Flight Procedures Cover Page	Task Action: FLIGHT CHECK	Task Type: SID	Estimated Chart Date: 12/31/2020	APWS Task ID: 46262A6BB92D43B0AA74D0AC472D46FC	APWS Project ID: A4862357228848E09DD2F35FF6382908
Procedure: SID WYNGS (RNAV) FIVE WASHINGTON DC KDCA		Enroute: YES	Specialist: Chaney, Andrea		Agreement Number:
Airport ID: KDCA	Airport Name: RONALD REAGAN WASHINGTON NATIONAL	Airport City: WASHINGTON			State: DC
Facility ID:	Facility Type:	Flight Inspection Remark Type: Hold FC Slot			
<p>Procedure Comments: ACTIVE DATA USED FOR KDCA DEPARTURE DEVELOPMENT.</p> <p>ATC REQUESTED CHANGES. APPROVAL LETTER FOR CLIMB GRADIENT. WAIVER FOR LENGTH OF SEGMENT.</p> <p>CONTACT GEORGE DAVIS (405) 954-9960/DAVID TEFFETELLER (202) 267-5177</p> <p>05/19/20: THIS IS AN UPDATED COPY OF THE FORM DEVELOPED ON 03/17/20. 1. ADDED NOTE: TURBO-JETS ONLY.</p> <p>10/22/20: THIS IS AN UPDATED COPY OF THE FORM DEVELOPED ON 03/17/20. 1. CHANGED RWY01 VI LEG DIST FROM 1.79 TO .61</p>

PROCEDURE: SID WYNGS (RNAV) FIVE WASHINGTON DC KDCA		AIRPORT NAME: RONALD REAGAN WASHINGTON		AIRPORT ID: KDCA	SPECIAL CONTROL NO: YG-09-116-20
FAC ID: WYNG5		CITY: WASHINGTON		ST: DC	ORIG CHART DATE: 12/31/2020
DFL TYPE: PROC/D	THIR

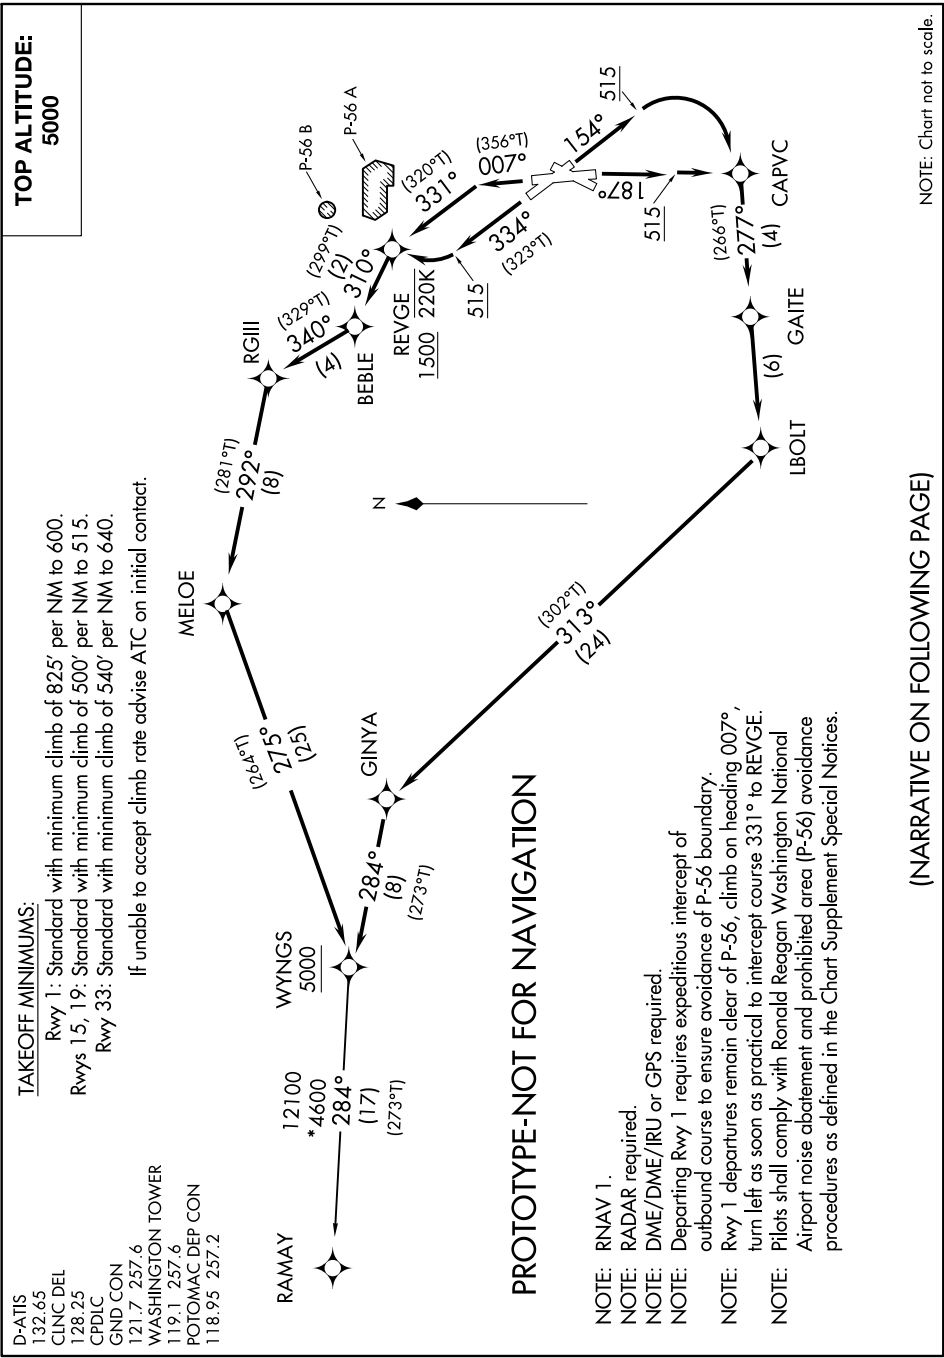
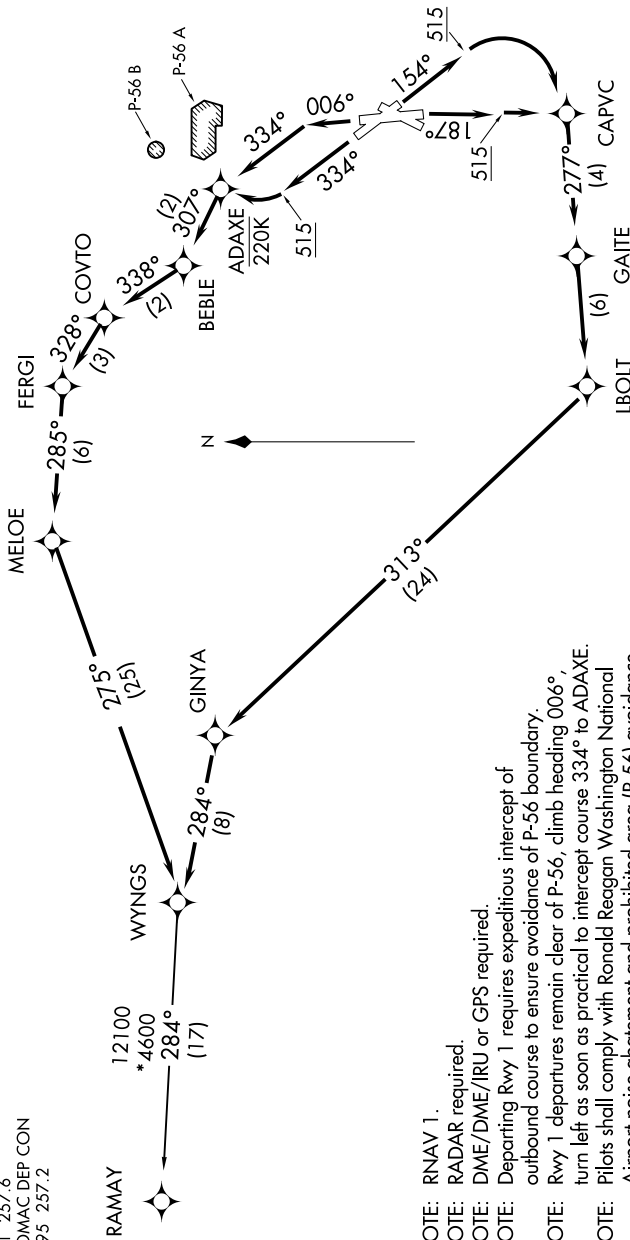
RWY01: Request approval for an 825 FT per NM climb gradient to 600 and a left turn as soon as practical to enable aircraft to intercept a 331 course to REVGE to avoid P-56 and to ensure obstacle clearance from a 595 MSL Monument (11-000021). This reflects the current CG as published and has been in use since March 31, 2016. The increased climb gradient is required in order to allow for LNAV engagement and to initiate a left turn to miss P56.
